Prepared for
Art Gallery of NSW
Date: 20 June 2019

Response to Submissions – Section 4.55(1A) Modification to SSD 6471

Art Gallery of NSW Expansion Project – Sydney Modern

Figure 3 Cooling Tower Distances

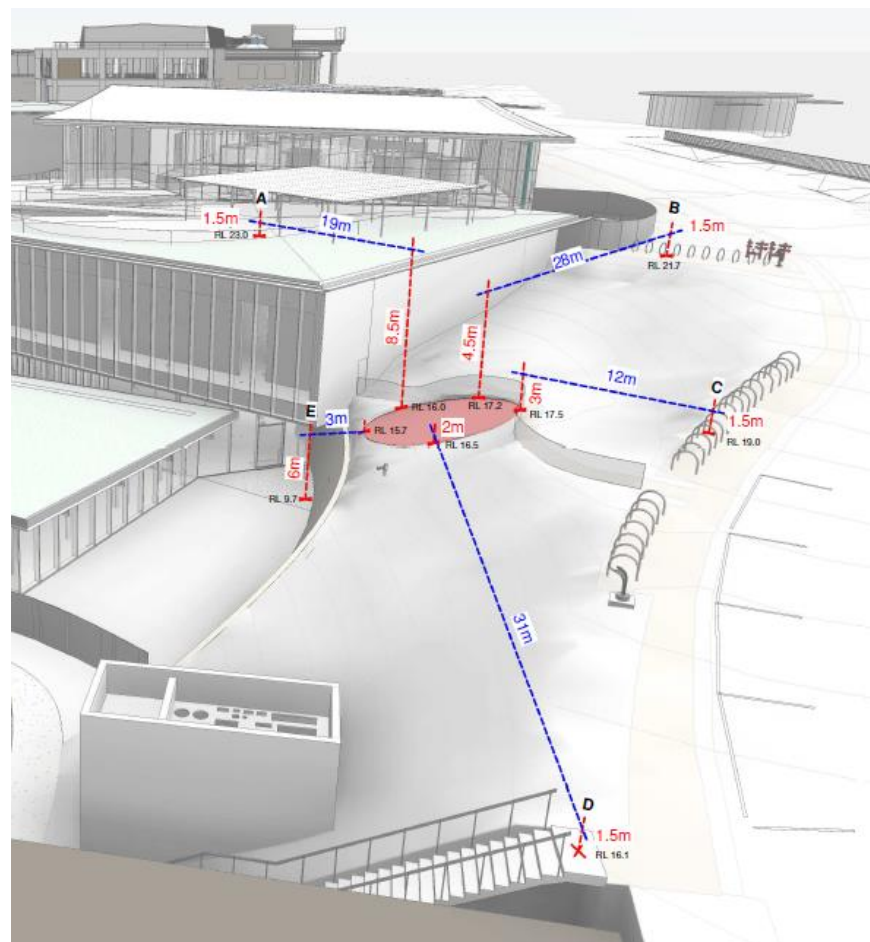
Council in their earlier email submission, query the impact of heat exhaust on pedestrian comfort.

Steensen Varming provides that the discharge from the exhaust will be approximately 5-6 degrees Celsius warmer than the air entering, and would mix quickly with the air, thereby it would only be perceived in close vicinity as warm humid air.

There is no point of pedestrian congregation at the location, and the adjacent path is only an emergency fire egress path from the building with glazed balustrade for its length preventing access to the air inlet/outlet grille from the path. The following diagram shows horizontal and vertical distances from the top of the cooling tower air inlet/outlet grille to public/pedestrian congregation areas (bicycle racks, public stairs, and roof terrace). These distances are adequate for dispersal of warm air so as not to pose an issue. Refer to discussion above on AS/NZS 3666.1:2011.

Dimensions show horizontal & vertical distances from cooling tower discharge.

Figure 4 Section A – Cooling Tower Sections (Scale 1:100)
Source: McGregor Coxall

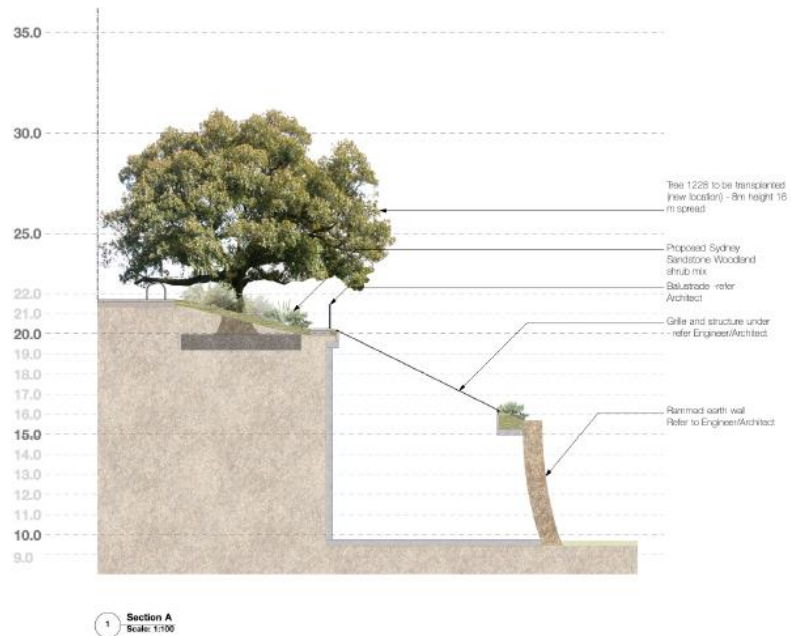
The City of Sydney Council requested additional information on the impact of the cooling tower exhaust on nearby existing and proposed trees. Council also requested design details of the air inlet/outlet grille in architectural and landscape documentation, and clarification of its impact on visual amenity, and comfort of the public domain.

In relation to the potential for thermal impact on vegetation from air inlet/outlet grille exhaust, McGregor Coxall landscape architects (refer **Appendix D**) provide there will be no impact on the long-term health of surrounding existing and proposed vegetation. This is given:

- There is a distance of 12.7 metres from the existing tree T1118 (edge of trunk) to the edge of the air inlet/outlet grille. The air inlet/outlet grille is located outside of the Tree Protection Zone (TPZ) and canopy of T1118;
- The distance from the relocated/transplanted T1228 (edge of trunk) to the edge of the air inlet/outlet grille is 4.5 metres;
- Air velocity from the air inlet/outlet grille (around 2 metres / second);
- Air temperature difference (around 5-6 degrees Celsius adjacent the air inlet/outlet grille and this warm air will dissipate and lessen as it moves outwards); and
- Trees are Australian natives and generally heat tolerant.

Detailed landscape plans have also been prepared by McGregor Coxall landscape architects with a plan and sections through the air inlet/outlet grille. Refer to the sections at **Figure 4** and **Figure 5** below and the full documentation at **Appendix E**.
